Re: Initial Submission Review: Painted Prairie Phase Five – Site Plan with Adjustments and Subdivision Plat
Application Number: DA-1556-22
Case Numbers: 2022-4005-00; 2022-3005-00

Initial Submission Review

GREEN VALLEY RANCH EAST
PRELIMINARY PLAT #7
TITLE: CARRIAGE HOUSE TYPICALS
DATE: November 2, 2021

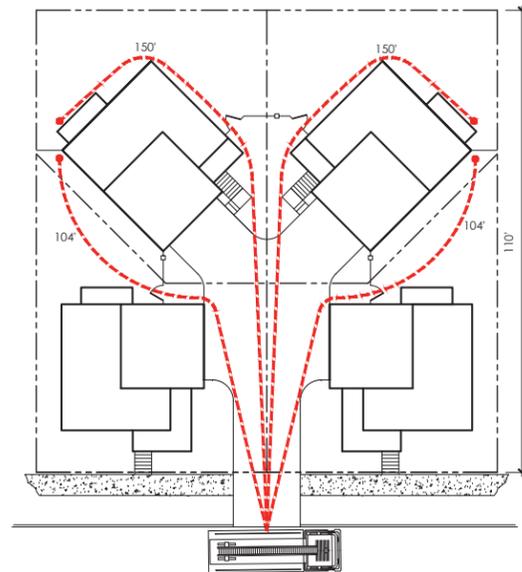
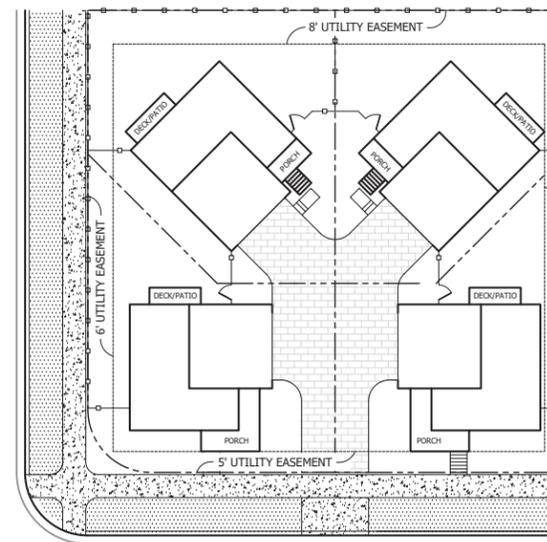
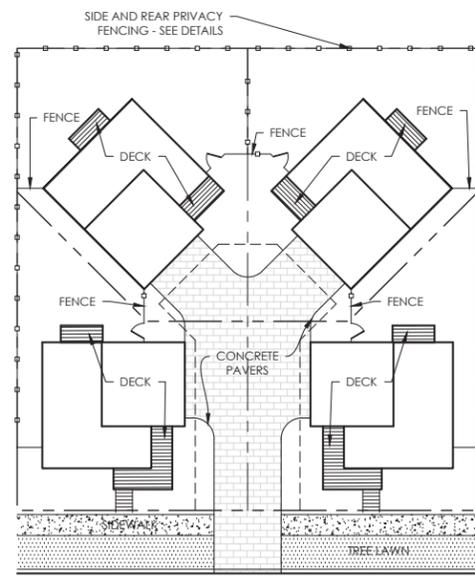
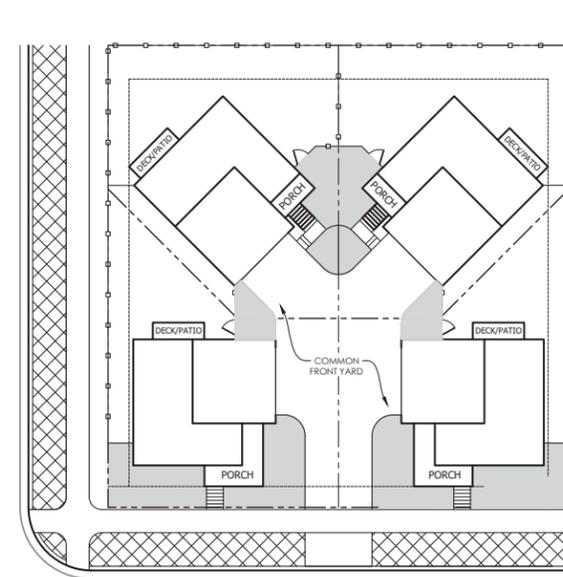
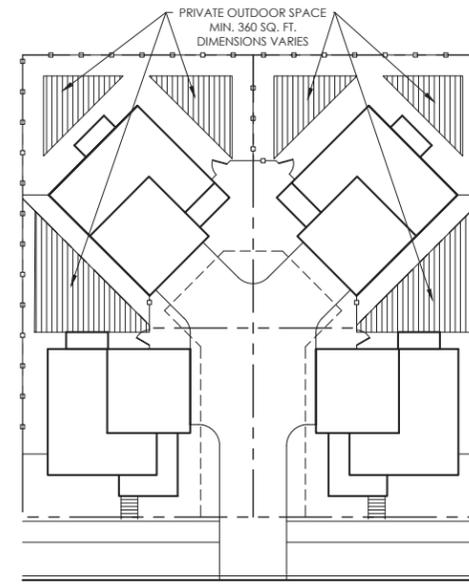
3D. There are specific requirements for motor courts in Section 146-4.2.3.E and the proposed motor court lots shall comply with these standards. The minimum lot size and width appear to meet the requirements, but more details are needed about the specific layouts that are proposed. Please review this section for requirements about setbacks, fences,, front door and porch locations, guest parking requirements, and minimum private open space requirements (180 sq. ft. minimum). Units adjacent to Iran Street shall have front doors facing Iran Street and units adjacent to Himalaya Road shall have front doors facing Himalaya Road. If doors do not front on Himalaya Road, an adjustment will need to be requested for double frontage lots. Details need to be added to the plan set to verify compliance with all requirements. An example of the details that should be provided is included as an attachment to the review letter.
